Access Compliance Report

Public Rights-of-Way

Intersection ID: 47753	Main Street: ARBOR_CREEK_DR	Cross Street: REBECCA_RUN_DR	Location: W
ADA ID: CF1BB0CBB0A7	Ramp Type: PerpDiag	Initial Pass/Fail: Fail	Overall Compliance: No
		Severity Score: 12.5

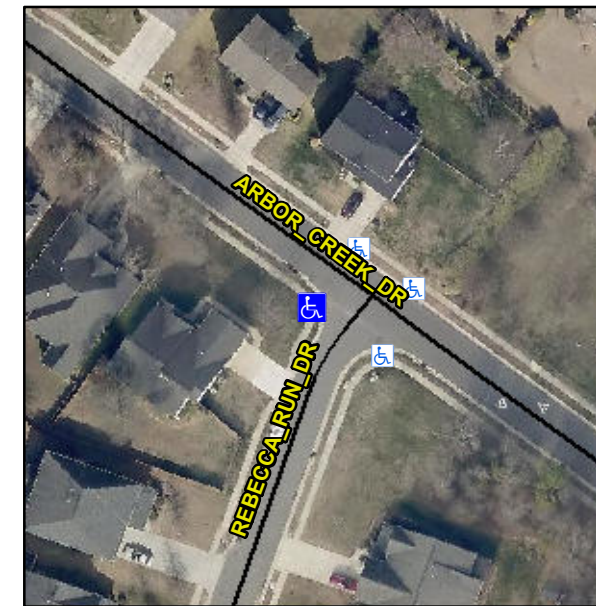
Not Found, R304.5.3

Compliance	Description	Data	Compliance	Description	Data
N/A	Ramp Length (in)	42.0	Yes	Ramp Slope (%)	6.6
Yes	Ramp Width (in)	48.0	No	Ramp XSlope (%)	5.8
N/A	Flare Type LT	N/A	N/A	Flare Type RT	N/A
N/A	Flare Slope LT (%)	N/A	N/A	Flare Slope RT (%)	N/A
N/A	Flare Traversable LT?	N/A	N/A	Flare Traversable RT?	N/A
N/A	Landing Length (in)	N/A	N/A	DWS Provided?	N/A
N/A	Landing Width (in)	N/A	N/A	DWS Contrast?	N/A
N/A	Landing Slope (%)	N/A	N/A	DWS Length (in)	N/A
N/A	Landing X Slope (%)	N/A	N/A	DWS Full Width?	N/A
N/A	Landing Curb? (Y/N)	N/A	N/A	DWS Offset (in)	N/A
N/A	Shared Landing?	N/A			
N/A	Gutter Ponding?	N/A	N/A	Gutter Slope (%)	N/A
N/A	Gutter Lip Ht (in)	N/A	N/A	Gutter X Slope (%)	N/A
N/A	Painted X Walk1?	No	N/A	Painted X Walk2?	No
	X Walk 1 Direction	To SE		X Walk 2 Direction	To NE
N/A	X Walk 1 Width (in)	N/A	N/A	X Walk 2 Width (in)	N/A
	X Walk 1 Slope (%)	1.6		X Walk 2 Slope (%)	2.6
	X Walk 1 X Slope (%)	7.4		X Walk 2 X Slope (%)	0.7

Remove & Replace Curb Ramp With Two New Directional Ramps or Equivalent.
